APPLICATION NO.	FILING DATE	FIRST NAMED INVENTOR	ATTORNEY DOCKET NO.	CONFIRMATION NO.
10/631,041	07/29/2003	Jean-Claude Villeneuve	TJK/403	9274
27717	7590	02/02/2006		
SEYFARTH SHAW LLP 55 E. MONROE STREET SUITE 4200 CHICAGO, IL 60603-5803			EXAMINER CAZAN, LIVIUS RADU	
			ART UNIT	PAPER NUMBER
			3729

Office Action Summary	Application No.	Applicant(s)	
	10/631,041	VILLENEUVE ET AL.	
	Examiner	Art Unit	
	Livius R. Cazan	3729

DETAILED ACTION

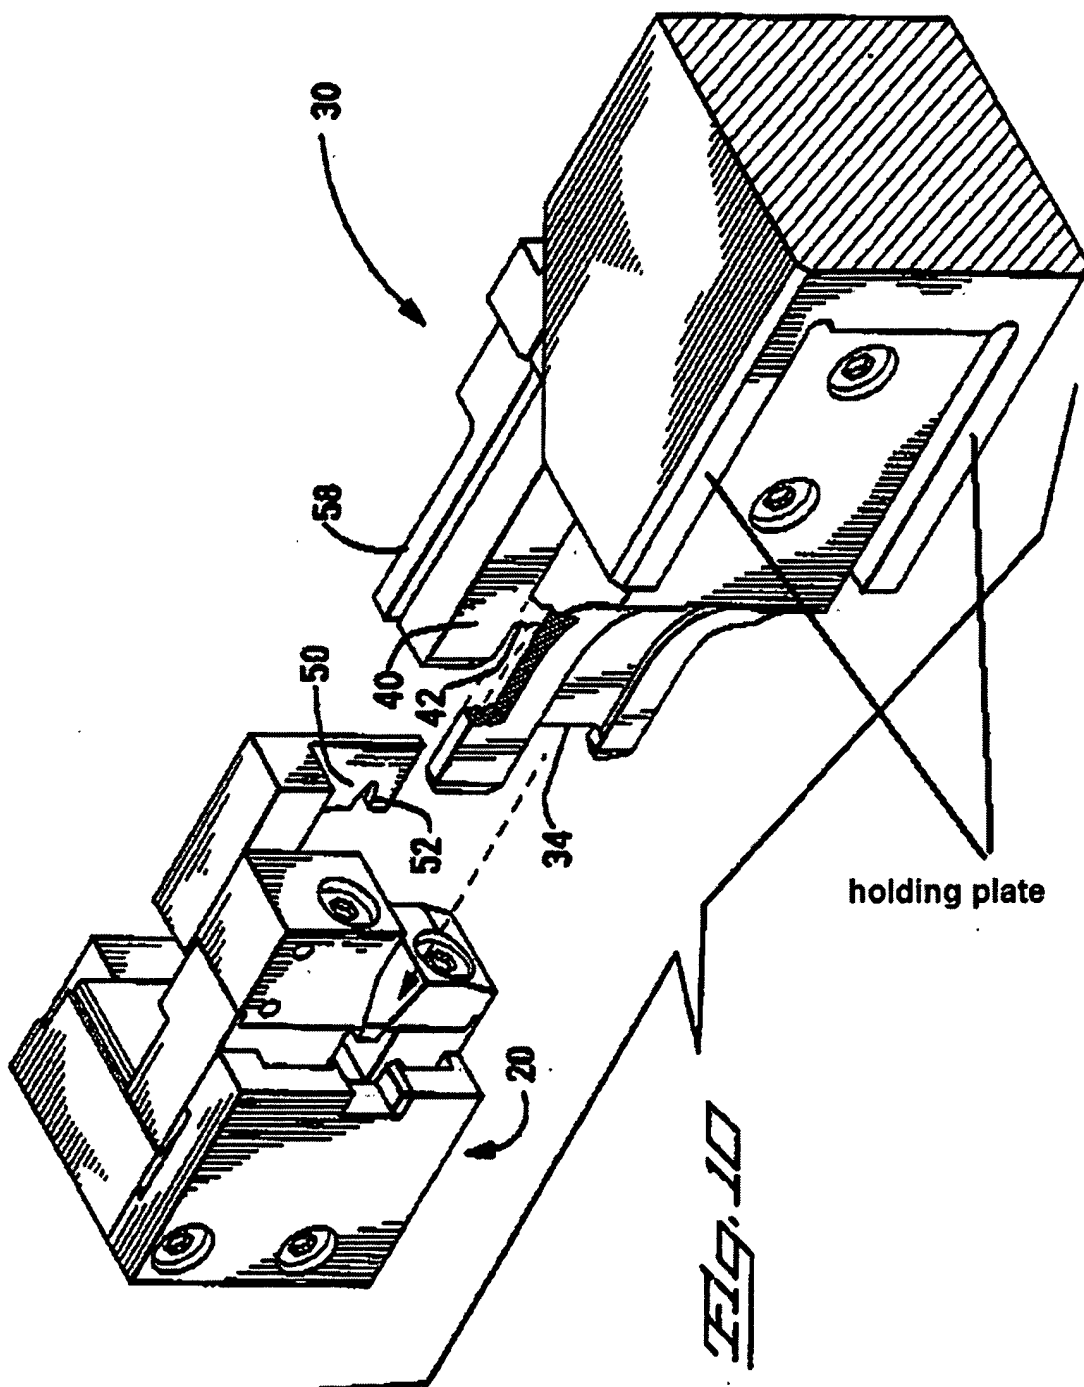
15. Claim 17 is rejected under 35 U.S.C. 103(a) as being unpatentable over Matsui in view of Orphanos et al. (US5357669)

Matsui discloses the same invention as the applicant, including a wire cutter tool operatively connected to a second actuator.

Matsui does not disclose a wire cutter tool mounted inside a holding plate.

Orphanos et al. teach a crimping apparatus which employs a cutter tool that is slidably mounted in a holding plate (see image below; also Fig. 10 in Orphanos et al.)

Therefore it would have been obvious to one of ordinary skill in the art at the time the invention was made to modify the wire cutter of Matsui, in view of the teachings of Orphanos et al., by employing a cutter which is slidably mounted in a plate, in order to facilitate quick removal and replacement with a different cutter.
